ENVIRONMENTAL IMPACT STATEMENT

KULAMANU STREET RELIEF DRAIN

HONOLULU, OAHU, HAWAII

SUBJECT: Draft Environmental Impact Statement for the Kulamanu Street Relief Drain, Honolulu, Oahu

EXHIBIT NO. 2A OUTLET DETAILS

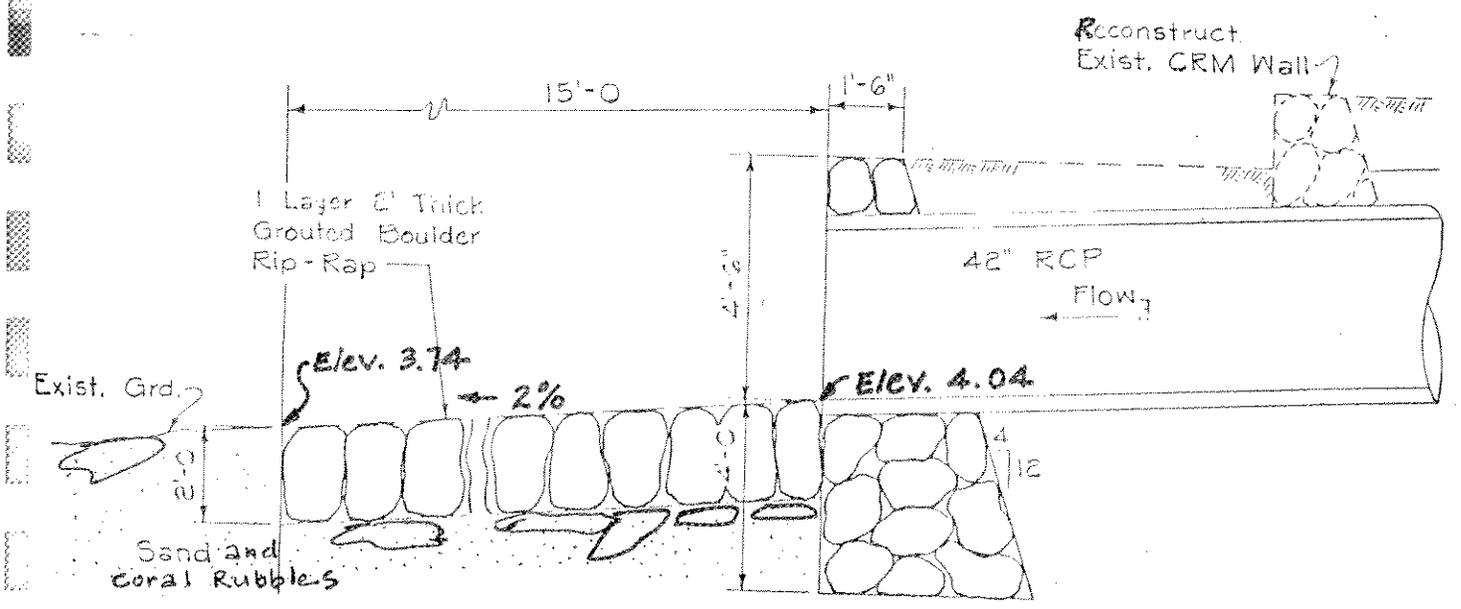
We have a few specific concerns with the outlet structure. The proposed new outlet structure (Exhibit 2) is 10 feet wide and will extend 15 feet across the existing sand beach. How far will the seaward terminus of this structure be from the maximum reach of high tide? How far will the new grouted concrete-rock

apron extend beyond the existing apron? Will the old apron be removed? Will the seasonal movement of sand on and off shore at this beach?

- a. The outlet detail plan (Exhibit No. 2) shows sand underneath riprap. The photograph indicates only a thin sand covering over rock or reef pavement. If there is a considerable depth of sand beneath the riprap, a bedding layer should be provided.
- b. A Department of the Army Section 10 permit may not be required if no work is to be done below mean high water; however, elevations at the outlet project site are needed prior to making a determination.
- c. As stormwater runoff is a pollutant source, EPA should be contacted. Consideration to controlling runoff flows by ponding or flow restriction to reduce mass volume freshwater discharge could be given in the alternative analysis.

The invert of the 42-inch outlet will be 4.04 feet above the MSL (Mean Sea Level) and the outlet apron will extend about 10 feet at 2% slope. The elevation of the makai end of the apron will be 3.74 feet above MSL and will be about 1.35 feet above the elevation of the highest tide (2.39 feet above the MSL) recorded by the U. S. Coast and Geodetic Survey in the Oahu area. The new outlet apron will be adjacent to and match the existing one.

A field inspection has indicated that the existing ground at the proposed outlet consists of coral rubble and a thin layer of sand. The proposed two foot thick grouted boulder rip-rap will rest on the rubble and a bedding layer is not necessary.

The final elevation of the proposed apron will be 3.7⁴ feet above the Mean Sea Level (MSL) or 2.67 feet above the Corps' Permit requirement. A clearance with the Corps for construction of this project has already been obtained.

Picture E and F. Kulamanu Place and the Existing 36" outlet (The proposed new relief drain outlet will be at the right side of the existing outlet).

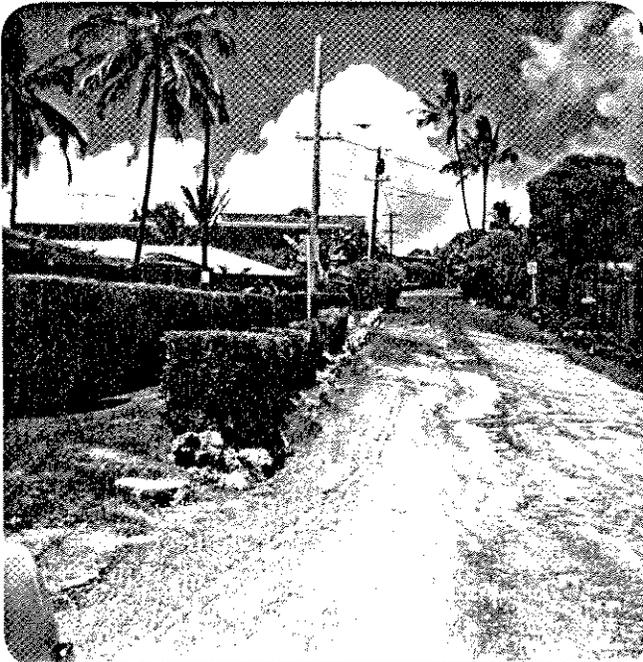
1. It is not clear in the EIS whether the new drainage system will replace the old system or if it will be an entirely new system. From the caption for Pictures E and F in Exhibit No. 3, it seems that the 42" will be placed Kokohead of the 36", which could mean an entirely new system. However, nowhere else in the EIS is this elaborated in discussion for full understanding. A diagram of the old and new system would also be helpful.
2. On our site visit, we noted an 18"(?) drain outlet Diamond Head of the 36". Is this 18" now non-functional? With the installation of the 42" outlet will the 36" also become non-functional?
3. If the 18" and/or 36" are no longer needed, would it not seem preferable to have them removed and the rockwall filled?

The existing drainage system will be retained. The new 42-inch drain pipe will be constructed parallel to the existing 36-inch pipe and will be located on the Koko Head side of Kulamanu Place. A diagram of the existing and proposed system will be attached in the final EIS.
